Project	<b>IEEE 802.16 Broadband Wireless Access Working Group</b> < <a href="http://ieee802.org/16">http://ieee802.org/16</a> >	
Title	<b>WirelessMAN coexistence function primitives consolidation</b>	
Date Submitted	<b>2008-05-02</b>	
Source(s)	Wu Xuyong Huawei, Huawei Industry Base, Bantian, Longgang, Shenzhen, China 518129	Voice: +86-755-28971787 Fax: +86-755-28972352 <a href="mailto:wuxuyong@huawei.com">wuxuyong@huawei.com</a>
Re:	IEEE 802.16-08/019 IEEE 802.16 Working Group Letter Ballot Recirc #29b: Announcement (2008-04-07)	
Abstract	<b>Semantic consolidation on Coexistence Functionality primitives in 16h, moving CX proxy description into Annex and generalize the network address for basic connectivity between WirelessMAN-CX systems.</b>	
Purpose	To consolidate the 16h draft.	
Notice	This document has been prepared to assist IEEE 802.16. It is offered as a basis for discussion and is not binding on the contributing individual(s) or organization(s). The material in this document is subject to change in form and content after further study. The contributor(s) reserve(s) the right to add, amend or withdraw material contained herein.

## WirelessMAN coexistence function primitive

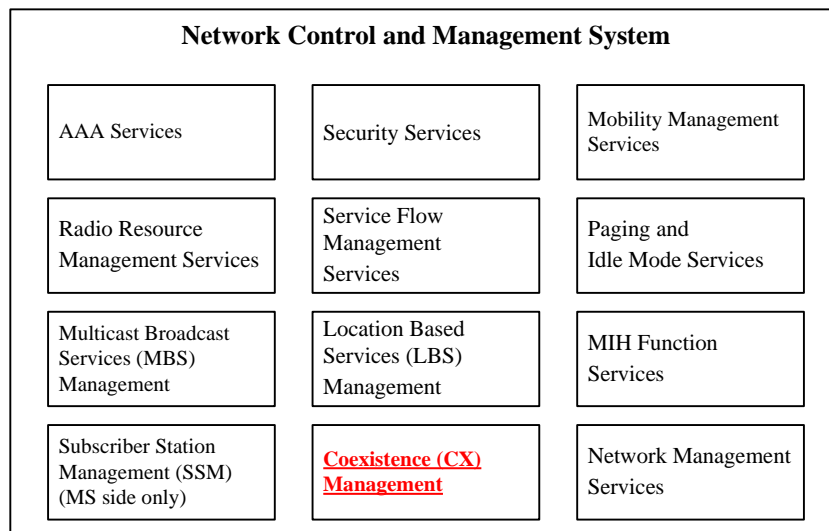
*Modified the figure 3 in 1.4.4 accordingly:*

Figure xx1. primitive flow of C-CX-REQ/RSP

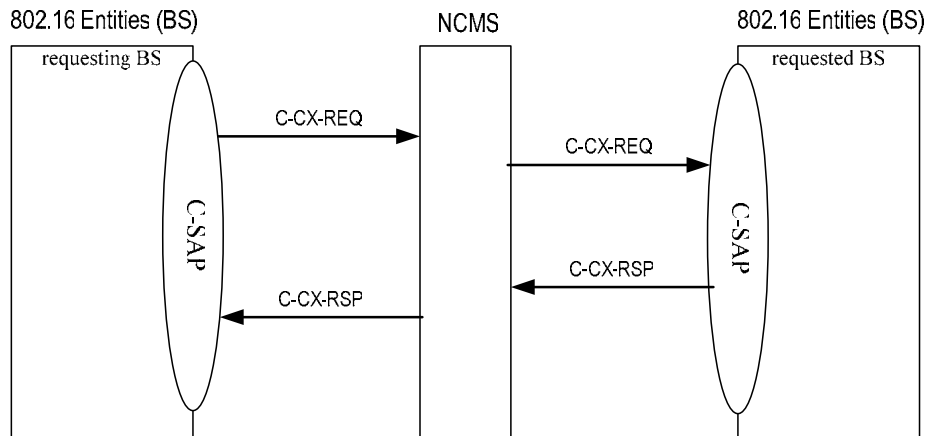
Add a new section 14.2.12 in 14.2, or replace according content in 15.6 with following:

The CX primitives are a set of primitives for supporting CX procedures between BS and NCMS.
